Access Compliance Report

Public Rights-of-Way

(Curb Ramps)

Intersection ID: 13343	Main Street: E_INDEPENDENCE_BV	Cross Street: N/A	Location: E
ADA ID: E66B09E8010C	Ramp Type: Para	Initial Pass/Fail: Fail	Overall Compliance: No
			Severity Score: 13.75

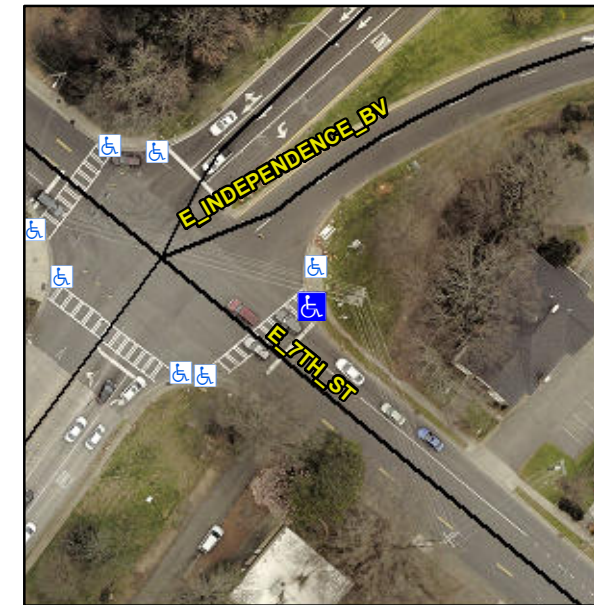
R304.3.2, R304.5.3

Compliance	Description	Data	Compliance	Description	Data
N/A	Ramp Length LT (in)	66.0	N/A	Ramp Length RT (in)	58.0
Yes	Ramp Width LT (in)	88.0	Yes	Ramp Width RT (in)	94.0
No	Ramp Slope LT (%)	10.0	Yes	Ramp Slope RT (%)	5.3
No	Ramp XSlope LT (%)	2.9	Yes	Ramp XSlope RT (%)	0.9
N/A	Landing Length (in)	N/A	N/A	DWS Provided?	N/A
N/A	Landing Width (in)	N/A	N/A	DWS Contrast?	N/A
N/A	Landing Slope (%)	N/A	N/A	DWS Length (in)	N/A
N/A	Landing X Slope (%)	N/A	N/A	DWS Full Width?	N/A
N/A	Landing Curb? (Y/N)	N/A	N/A	DWS Offset (in)	N/A
N/A	Shared Landing?	N/A			
N/A	Gutter Ponding?	N/A	N/A	Gutter Slope (%)	N/A
N/A	Gutter Lip Ht (in)	N/A	N/A	Gutter X Slope (%)	N/A
N/A	Painted X Walk1?	Yes	N/A	Painted X Walk2?	N/A
	X Walk 1 Direction	To SW		X Walk 2 Direction	N/A
N/A	X Walk 1 Width (in)	111.0	N/A	X Walk 2 Width (in)	N/A
	X Walk 1 Slope (%)	5.3		X Walk 2 Slope (%)	N/A
	X Walk 1 X Slope (%)	1.8		X Walk 2 X Slope (%)	N/A
N/A	Ramp inside XWalk1?	Yes	N/A	Ramp inside XWalk2?	N/A

Remove & Replace Entire Ramp.
